LINCOLN ELECTRIC EUROPE

Service Notice N°: ESN0078 Rev.01

Random shut down of front panel PCB

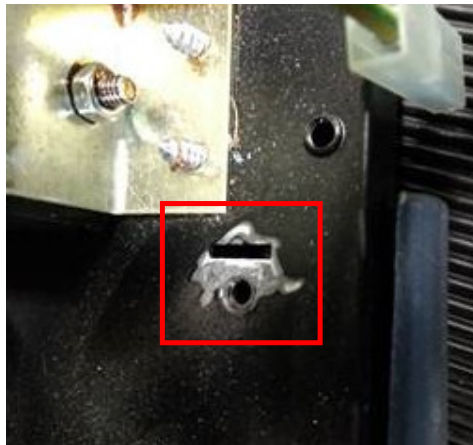
Randomly, after starting or during welding, the front panel turns off completely and the welding arc is extinguished

1. Remove the machine cover.
2. Locate all earth/ground connectors fixed on the machine metal frame
3. Remove the earth/ground wires from the connectors
4. Remove the earth/ground connectors from the machine metal frame and remove the paint that is present between the connector and the frame as shown into the below picture

Problem can be solved by cleaning from the paint the area under the earth connectors. In addition, **only on the INVERTEC 175TP**, replacing the 7 metal standoff that are fixing the HF board (W000274816) and Control Panel PCB (R-6042-086-2R) with plastic ones.

5. Reinstall the earth/ground connectors to the machine metal frame
6. Connect again all the earth/ground wires to the connectors.
7. Close the machine with the cover.

Correction of the Problem for Invertec 175TP (K14169-1) 7 wrong metal standoff

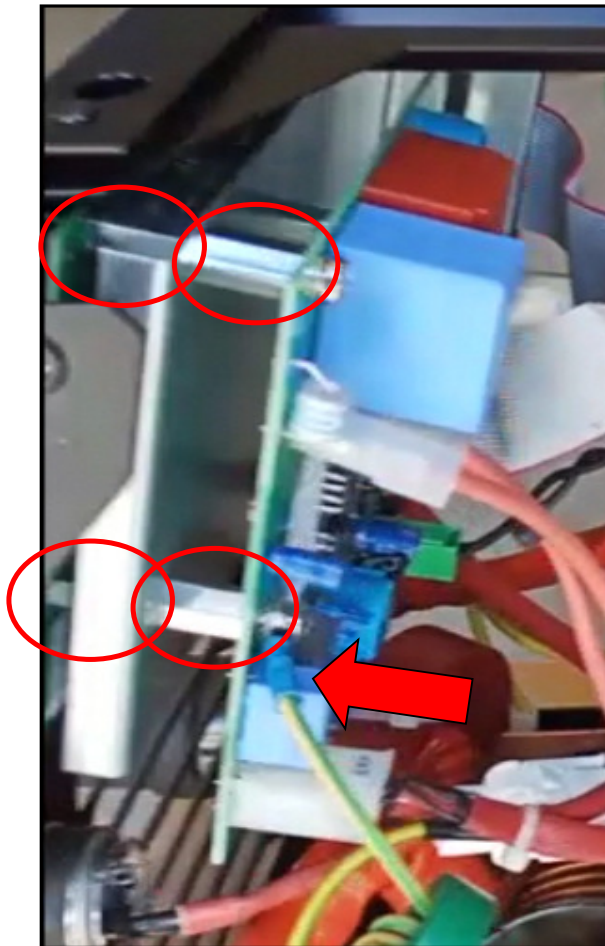
1. Remove the machine cover.
2. Locate the HF PCB and the Control Panel PCB mounted on the back of the machine front panel (the following picture is showing you the four standoff on the left side, three more are on the right side)

3. Remove the 3 screws that are fixing the HF PCB to the machine and remove the HF PCB from the machine.
4. Remove the 3 metal stands off and the metal plate.
5. Remove the 4 stands off that are fixing the Control Panel PCB and replace them with 4 plastic ones type: M4x15 M/F HEX NYLON - W8604080
6. Reassembly the metal plate, the 3 plastic stands off and the HF PCB, paying attention to connect again the earth cable (indicated by the red arrow into the above picture)
7. If you are not able to find the plastic stands off in your local market, please ask to send some to your attention to Lukasz Wardencki
